## Changes to the external appearance of LE7-40GU-L type tension controller

February 2020

LE7-40GU-L

#### 3.1 Changes of the external appearance of the Ethernet interface and USB interface

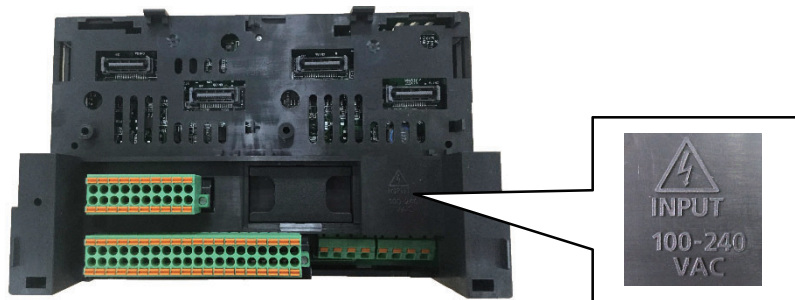
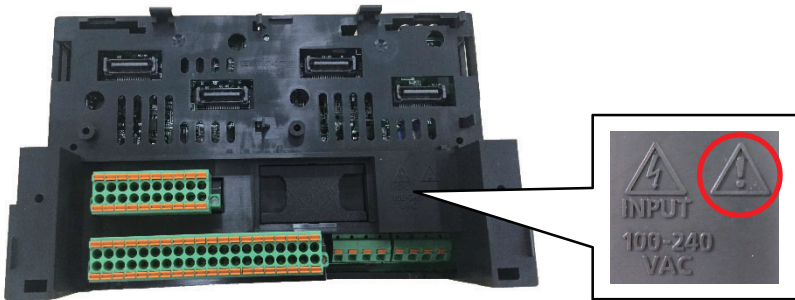
The Ethernet interface and USB interface on the side of LE7-40GU-L type tension controller will be changed as below.

Changed items: Ethernet interface and USB interface	
Before change	
After change	<p>The gap between the Ethernet/USB interface and the case will be reduced.</p>
